Report of the Bulletins and Orders Task Force

Office of
Nuclear Reactor Regulation

U.S. Nuclear Regulatory
Commission

NUREG-0645

Arkansas 2
Figure 1
EMERGENCY FEEDWATER SYSTEM

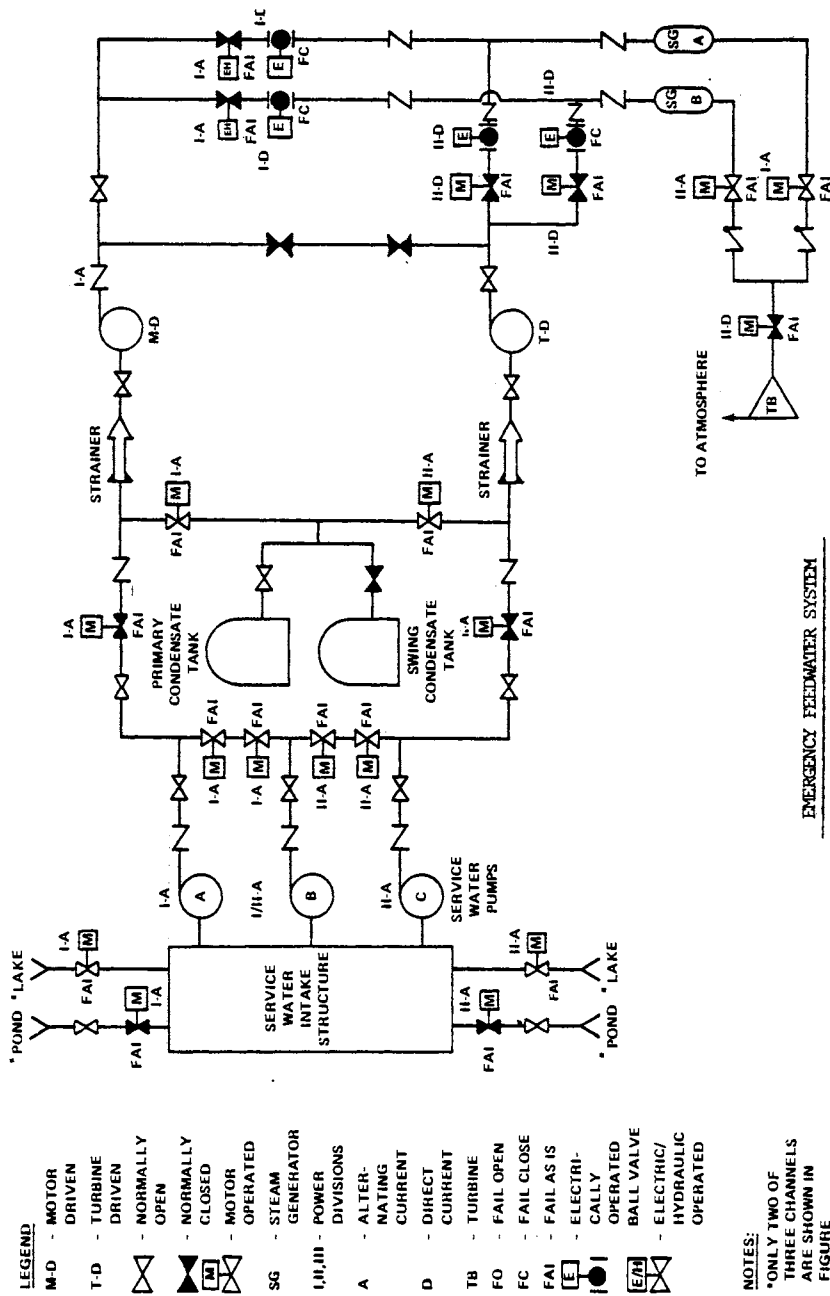
1. Recommendation - GL-5 - The licensee should upgrade the AFW system automatic initiation signals and circuits to meet safety-grade requirements.
2. Recommendation - The Arkansas Unit 2 AFW system design does not meet the high energy line break criteria in SRP-10.4.9 and Branch Technical Position 10-1; namely, that the AFW system should maintain the capability to supply the required AFW flow to the steam generator(s) assuming a pipe break anywhere in the AFW pump discharge lines concurrent with a single active failure.

Auxiliary Feedwater System
Calvert Cliffs, Unit 1 & 2
Figure 1

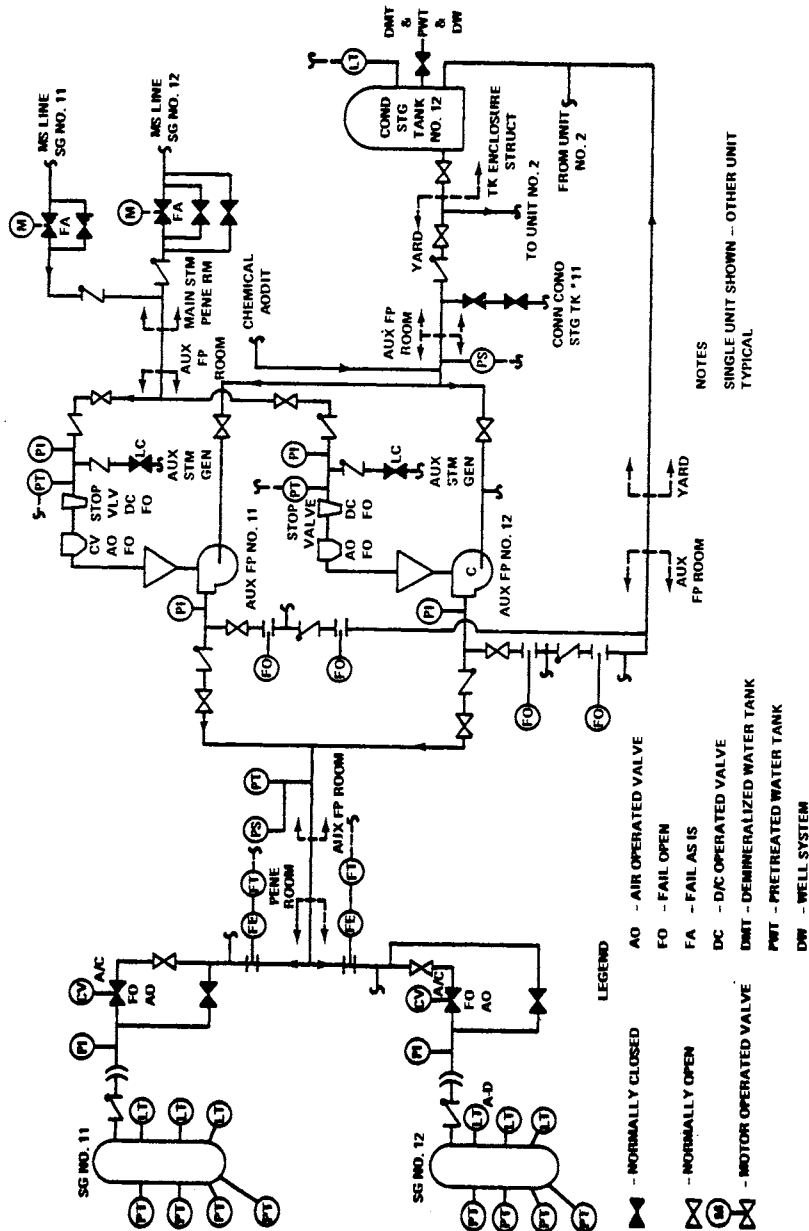
5. Recommendations - The licensee should evaluate the following concerns:
 - a) The AFW pump discharge lines and turbine driven AFW steam supply lines combine into different single lines through which all AFW water or steam must flow. (See Figure 1). A pipe break in either of these single flow paths would cause loss of the entire AFW function.

Auxiliary Feedwater System
Maine Yankee
Figure 1

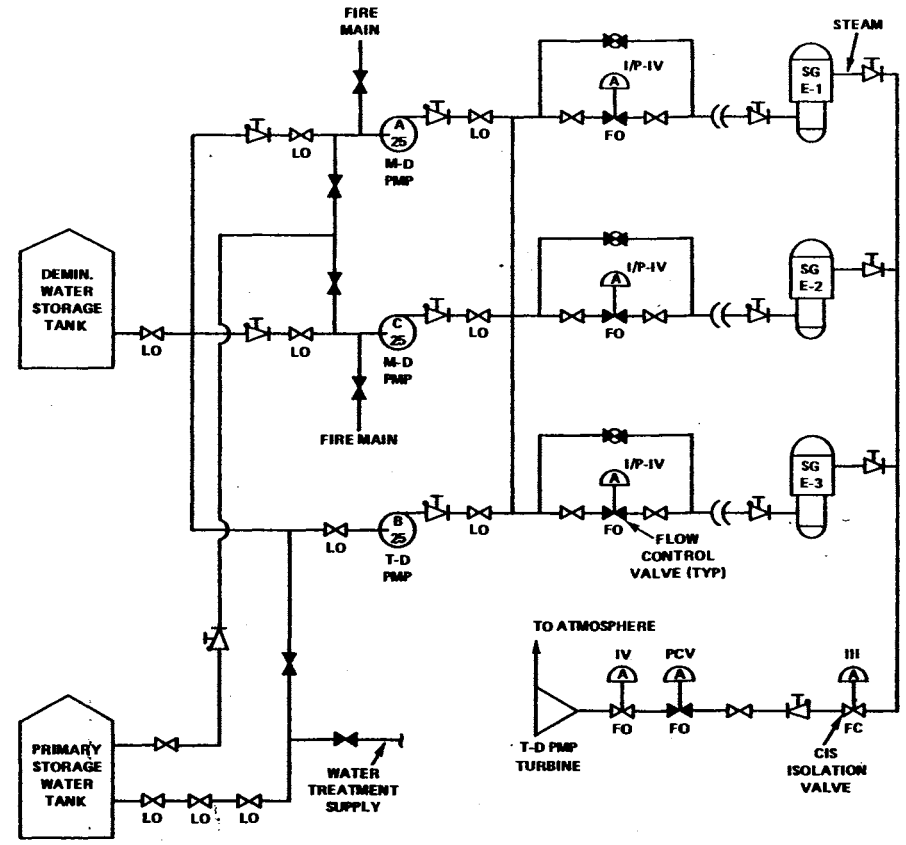
3. Recommendation - Modify the AFWS design to eliminate the potential for adverse response of the three AFW flow control valves and one of the steam admission valves to the turbine pump due to degradation of power of the Division IV vital bus, e.g., provide service to these valves from different Division.

4. Recommendation - The licensee should evaluate the following concerns:
 - a. A pipe break in the auxiliary feedwater system common discharge header could result in the loss of auxiliary feedwater ~~system function~~ even without a postulated single active failure. The licensee indicated that in such an event the auxiliary feedwater can be manually routed through the main feedwater lines to the steam generators.

- b. In the event of a steam or feedwater line break (main or auxiliary) the isolation of the auxiliary feedwater flow paths to the affected steam generator is accomplished manually. The licensee should evaluate the postulated pipe breaks stated above and (1) determine any AFW system design changes or ~~procedures necessary to detect and isolate the break~~ and direct the required feedwater flow to the steam generator(s) before they boil dry or (2) describe how the

Figure 1.

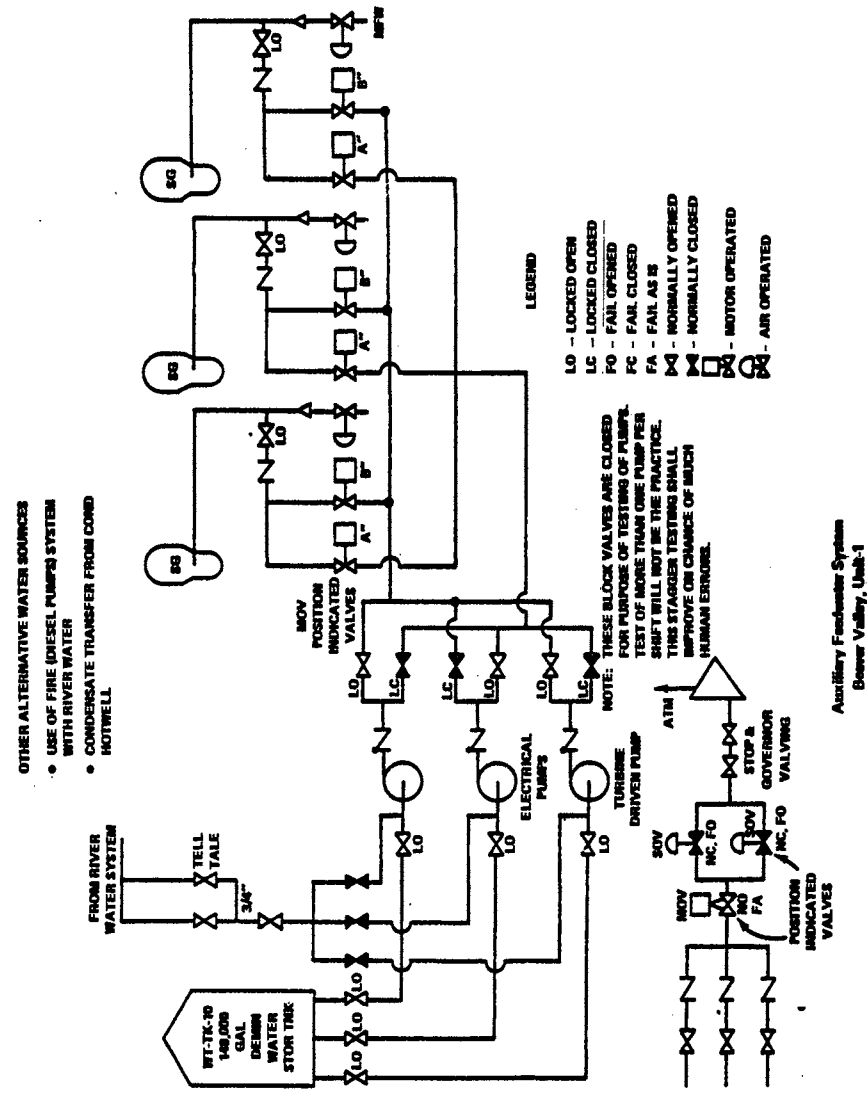
7. Recommendation - As shown in Figure 1, the locked block valves in each AFW pump discharge line are aligned so that the combined flow from one motor-driven pump plus one turbine-driven pump is supplied to the steam generators via one AFW header while flow from the remaining motor-driven pump is supplied to the steam generators via the redundant AFW header. As indicated in Section 1.1.1, the licensee states that, in the event of an unisolable main steam or main feed line break, the flow from both motor-driven pumps or from the turbine-driven pump is required to prevent dryout of the steam generators. The licensee should review the present alignment of the AFW pump discharge block valves and modify as necessary to provide the AFW required for normal, transient, and accident conditions.

Auxiliary Feedwater System
 D.C. Cook
 Figure 1 (Sheet 1 of 2)

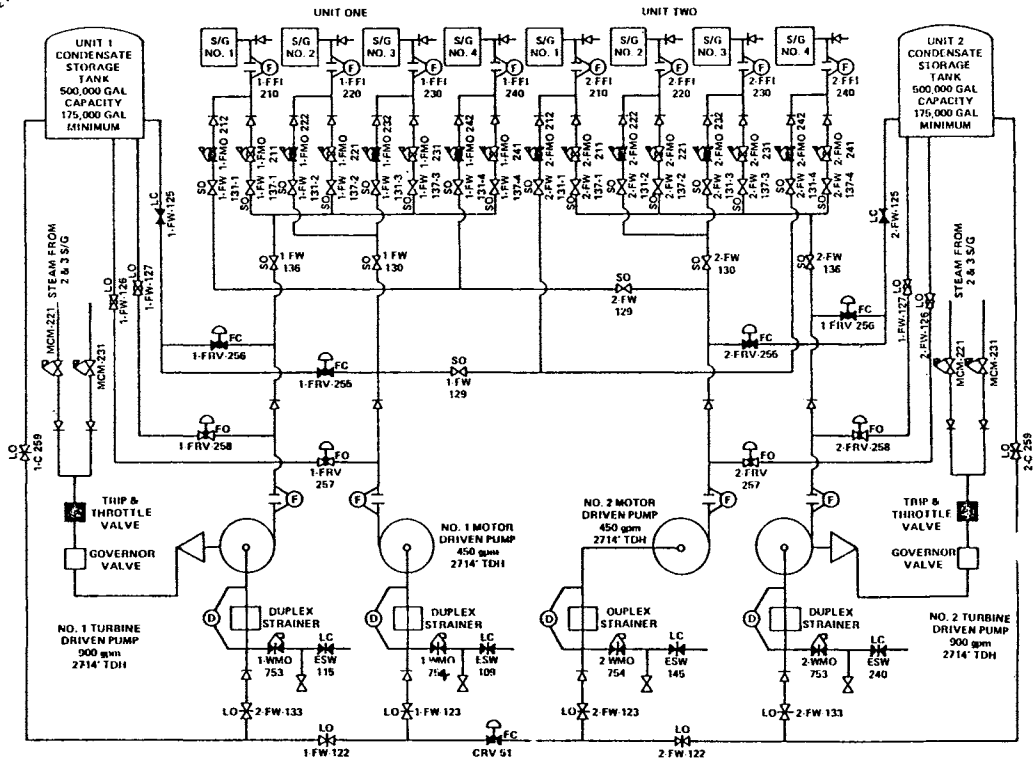
1. Recommendation - GL-3 - The licensee is currently performing modifications to make the turbine driven train independent of A-C power sources. The following recommendation should be met when these modifications are complete. At least one AFW system pump and its associated flow path and essential instrumentation

Auxiliary Feedwater System
H.B. Robinson
Figure 1

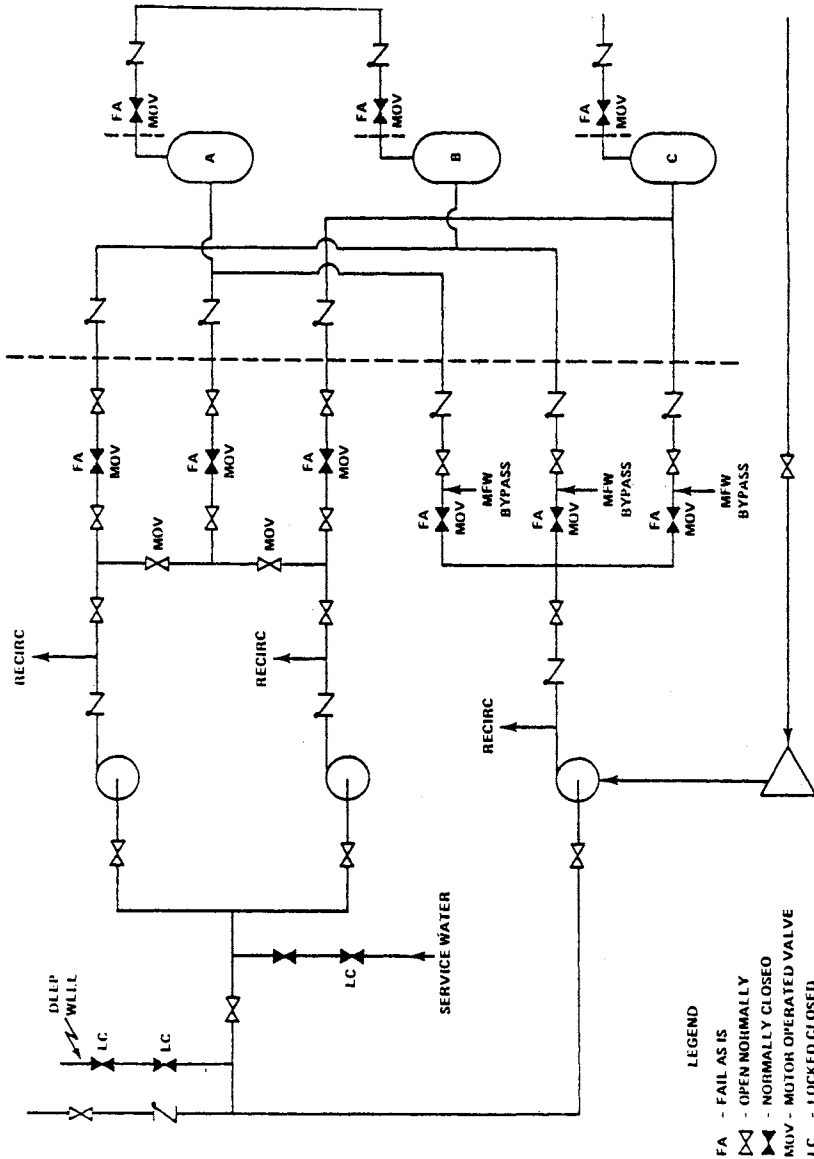
1. Recommendation GL-2 - Licensees with plants in which all (primary and alternate) water supplies to the AFW systems pass through valves in a single flow path should install redundant parallel flow paths (piping and valves).

Auxiliary Feedwater System
Haddam Neck
Figure 1

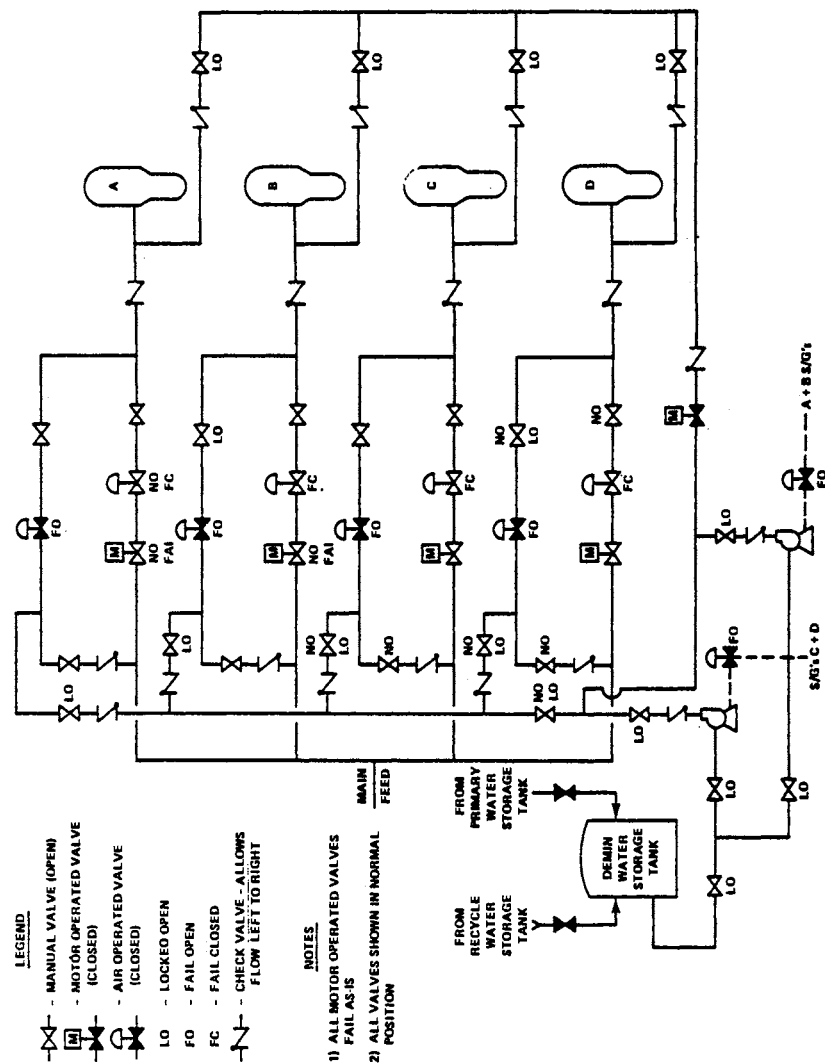
The licensee should propose Technical Specifications to incorporate appropriate periodic inspections to verify the valve positions.

2. Recommendation- GL-5 - The licensee should upgrade the AFW system automatic initiation signals and circuits to meet safety-grade requirements.
3. Recommendation - There is a common crossconnect line with no isolation valves between the two parallel flow paths on the S/G's. A break in this section cannot be isolated in the present design and the total system would be unavailable. It is recommended that some modifications be made (such as isolation valves) to provide isolation when necessary and assure a means of supplying AFW flow following isolation of such a break. The licensee has begun design plans to add a motor driven pump to the system. The licensee should introduce the flow from this third pump in such a manner that a break in this crossconnect

line will not result in the loss of all pumps. Also the licensee should 1) install the third pump with appropriate valves in the pump discharge line connections to meet the high energy line break criteria in SRP 10.4.9 and Branch Technical Position ASB 10-1; namely, to maintain the capability to supply the required AFW flow to the steam generators with a postulated pipe break anywhere in the AFW pump discharge lines plus a single active failure, or 2) describe how the plant can be brought to a safe shutdown condition by use of other available systems following such a postulated event.

Auxiliary Feedwater System
Indian Point-2
Figure 1

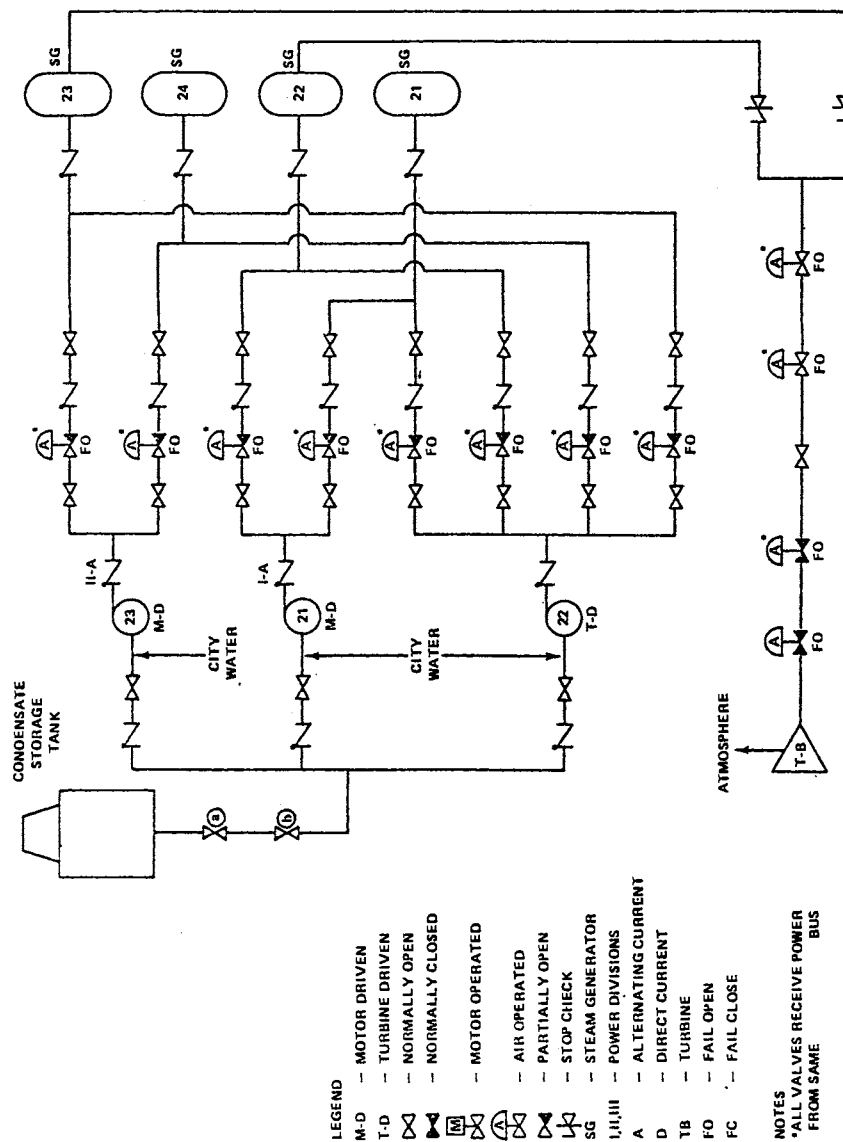
The licensee should propose Technical Specifications to incorporate appropriate periodic inspections to verify the valve positions.

2. Recommendation GL-5 - The licensee should upgrade the AFW system automatic initiation signals and circuits to meet safety-grade requirements.
3. Recommendation - The two motor-driven pumps and the turbine driven pump are located in the same room. The licensee should evaluate the capability of the design to withstand a) environmental conditions (steam, flooding, pipe whip and jet impingement) resulting from a pipe break, b) internally generated missiles.

The licensee should evaluate the postulated pipe breaks stated above and (1) determine any AFW system design changes or procedures necessary to detect and isolate the break and direct the required feedwater flow to the steam generator(s) before they build dry or (2) describe how the plant can be brought to a safe shutdown condition by use of other systems which would be available following such postulated events.

Figure 1
Turkey Point (Units 3 and 4)
Auxiliary Feedwater System

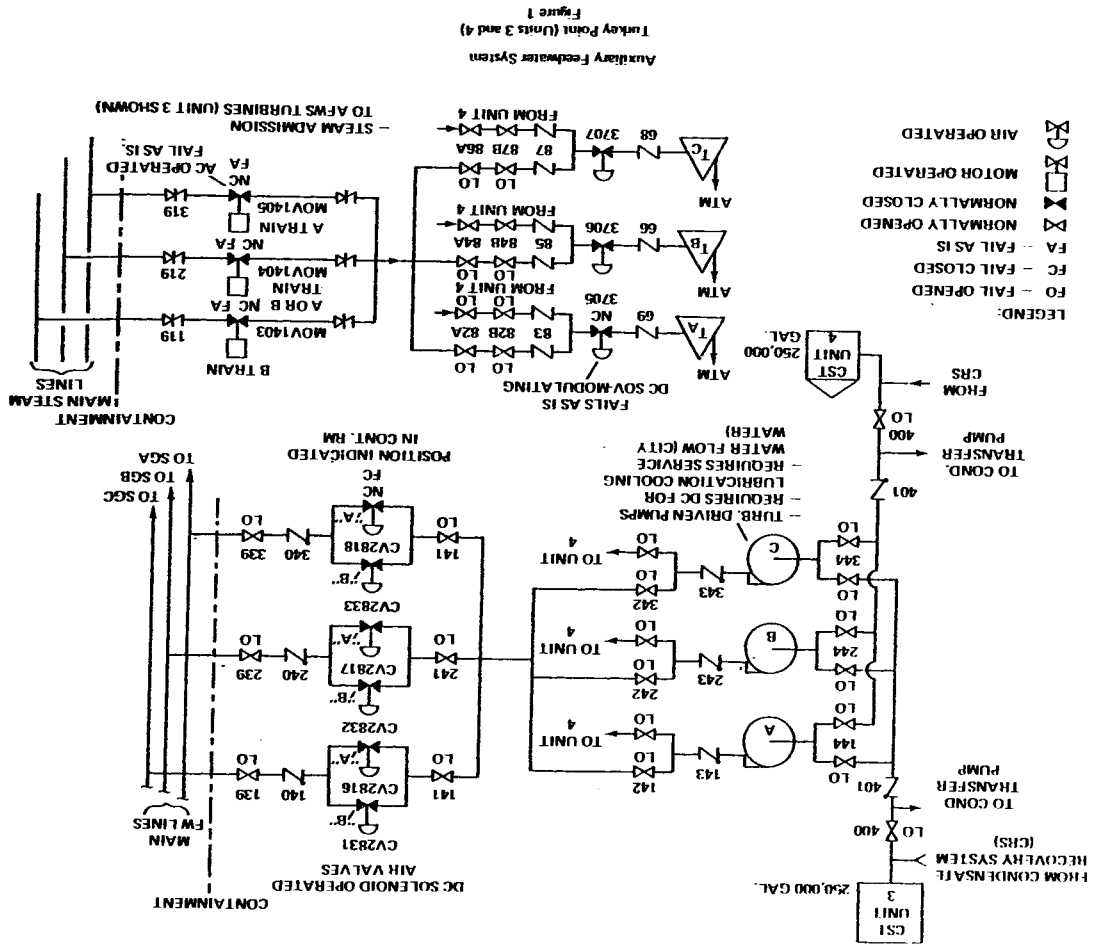
- 4. Recommendation -** The lube oil cooling of the three turbine driven AFW pumps is provided from a common source; namely the service (city) water system. The licensee should evaluate this cooling water system to determine if there are potential common mode (electrical or mechanical) failures that could disable the lube oil cooling for all three turbine driven pumps. The licensee should provide the results of the evaluation and 1) indicate any system modifications or procedures necessary to prevent a common mode failure of the lube oil cooling system or 2) provide information that demonstrates that the turbine driven AFW pumps can operate for at least two hours without lube oil cooling water and independent of AC power.

Auxiliary Feedwater System
Zion
Figure 1.1a.1

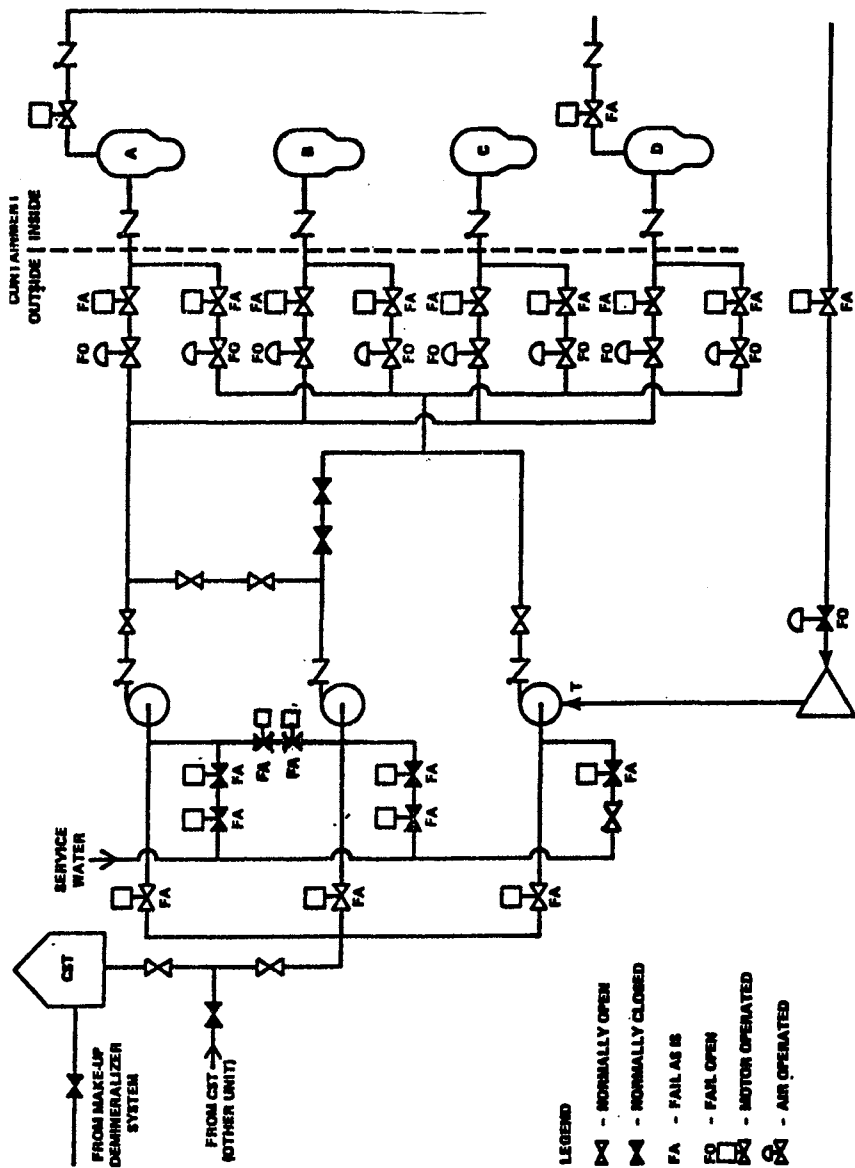
1. Recommendation GL-2 - Licensees with plants in which all (primary and alternate) water supplies to the AFW systems pass through valves in a single flow path should install redundant parallel flow paths (piping and valves).

Licensees with plants in which the primary AFW system water supply passes through valves in a single flow path, but the alternate AFW system water supplies connect to the AFW system pump suction piping downstream of the above valve(s), should install redundant valves parallel to the above valve(s) or provide automatic opening of the valve(s) from the alternate water supply upon low pump suction pressure.
